Engineering Advice – Revision 1

Resource Consent Number: RC250259

Short Description/Proposal: Proposal includes the creation of 4 Rural Residential titles comprising a total area of 16.5 ha plus 3 titles within the balance land to be retained by the partners comprising .5 ha each. The latter titles will include a right to an undivided one third share in the balance land being 191.657 ha Lot 1. The proposal proposes a QEII covenant over 182 ha that will provide for the protection of the outstanding natural landscape that exists here from further building development or subdivision and to facilitate the ongoing restoration of the natural vegetation. A weed control and native species planting program has been developed and is in train. In addition to the subdivision, a minor boundary change is being proposed to resolve an adverse occupation.

Flood Risk

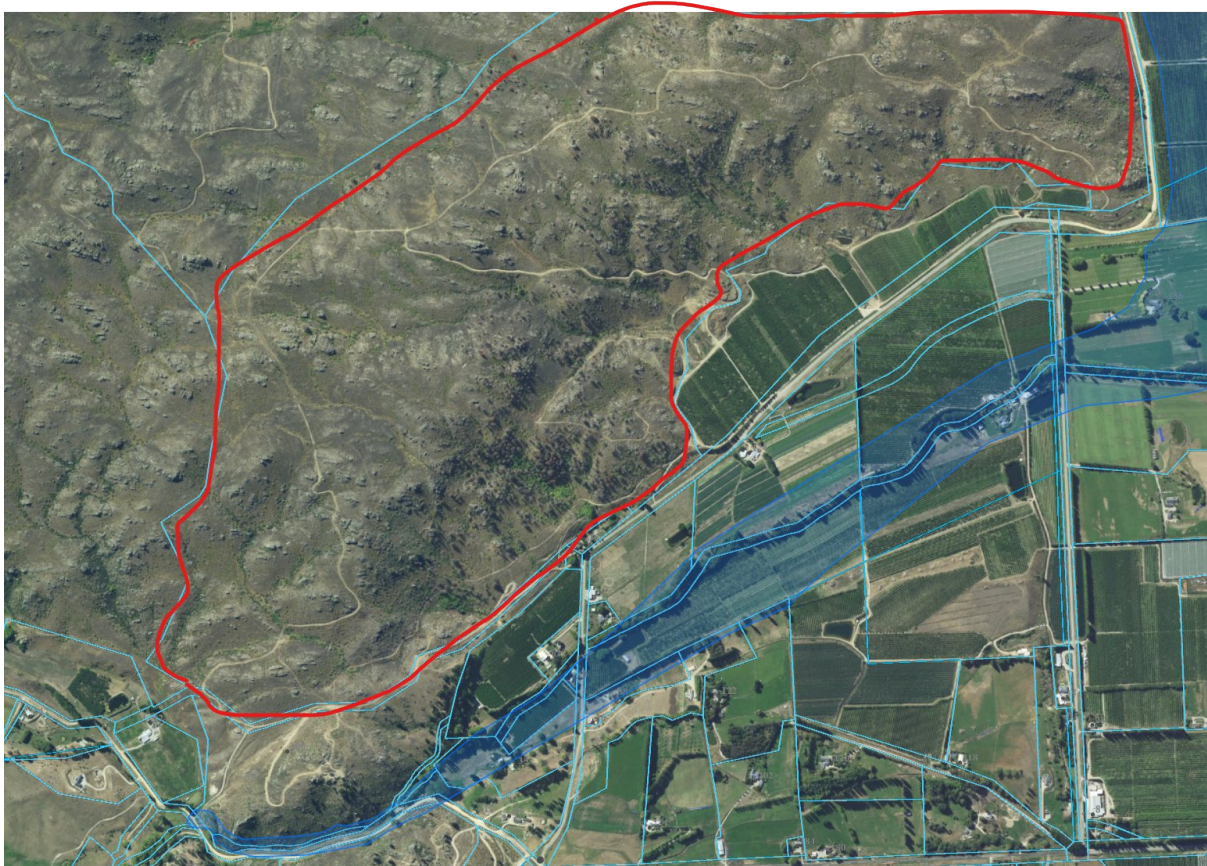
Commentary: The application is silent on flood risk, however, a review of the ORC Flood Hazard Map indicates that no flood risk exists on the applicant's land (denoted with a red outline below).

None applicable.
